South Texas Project Electric Generating Station P.O. Box 289 Wadsworth, Texas 77483

July 27, 2010
U7-C-STP-NRC-100170

South Texas Project
Units 3 and 4
Docket Nos. 52-012 and 52-013
Response to Request for Additional Information

Attached is the STP Nuclear Operating Company (STPNOC) response to Request for Additional Information (RAI) question 02.04.05-10 in RAI letter number 334 related to COLA Part 2, Tier 2, Section 2.4S.5, "Probable Maximum Surge and Seiche Flooding." This letter provides the complete response to RAI letter number 334. The attachment provides the response to the following RAI:

Figure 1, ADCIRC Results for the PMH with a Northwest Track passing West of the STP Site

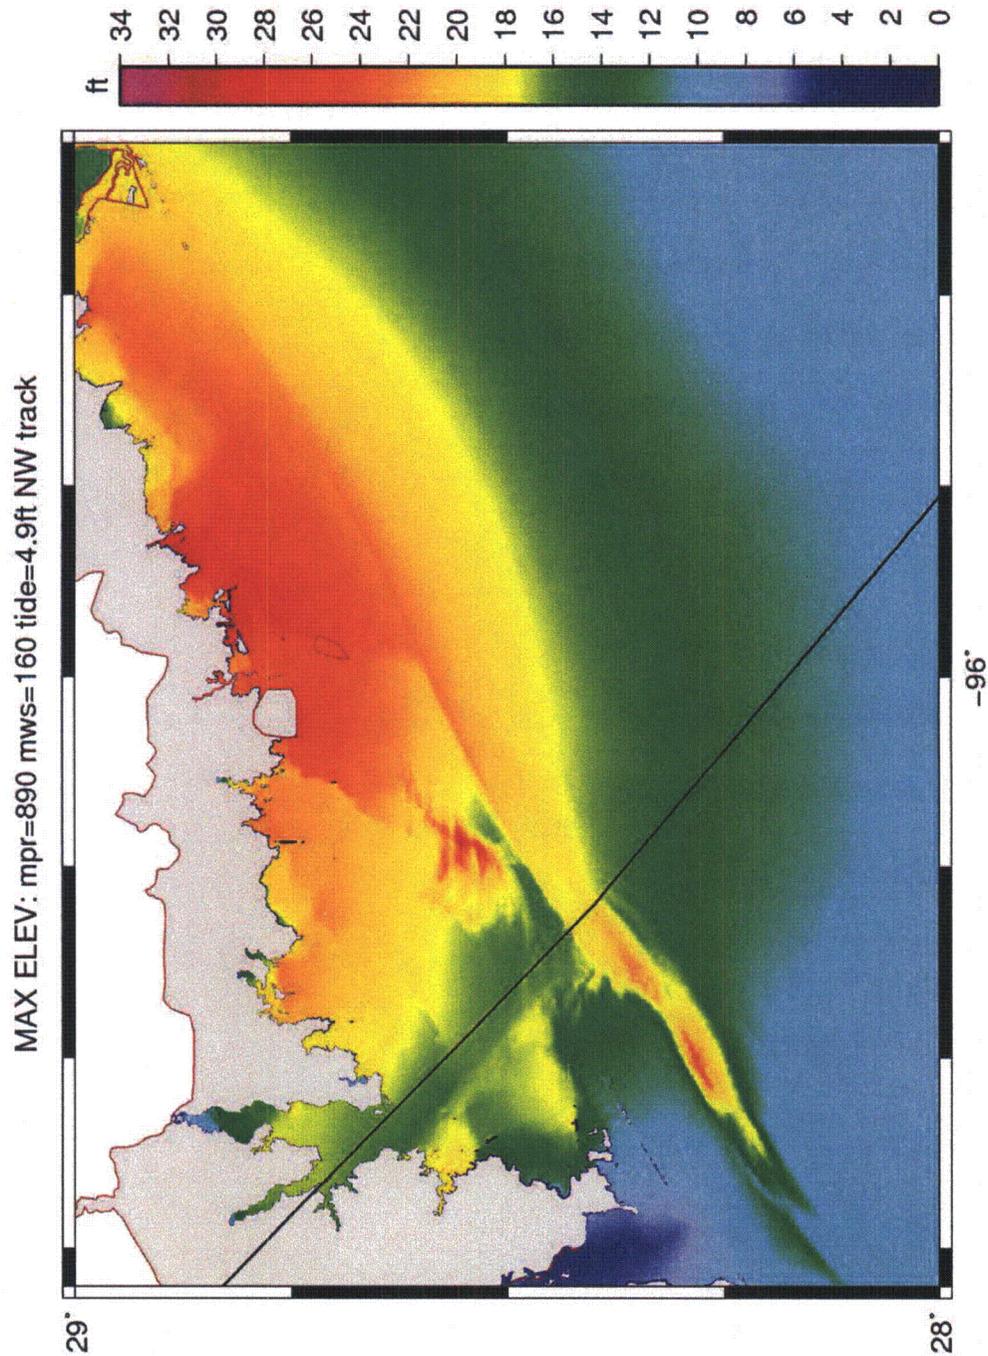
Please provide the following information: (a) an analysis of the PMSS event using a conservative approach such as those predicted by a storm surge model (e.g., SLOSH) with input from appropriate PMH models, (b) reasons why exposure of the outer face of the MCR embankment to the PMSS event would not lead to a breach, and (c) if an MCR breach is postulated under PMSS conditions, a revised estimate of the design-basis flood water surface elevation at the STP site.

- ADCIRC more accurately models topographic features that block or accelerate storm surge flooding (e.g. highways) than SLOSH. This feature of ADCIRC is particularly relevant to STP because the barrier islands along the Texas Coastline south of the STP site and the levee surrounding the City of Matagorda southeast of the STP site influence predicted storm surge levels at the STP site (see Figure 1 and Figure 2).

Model 5: This STP confirmatory analysis is based on ADCIRC Version 49 and Texas Grid Version 13 and assumed that PMH intensity started to decay only after landfall. This model predicted the PMSS at the Gulf Coast is 21.5 feet MSL. This model predicted the PMSS at the STP site, including wave runup, is 26.5 feet MSL. The predicted maximum surge at STP is less than the site grade (Figures 1 and 2).
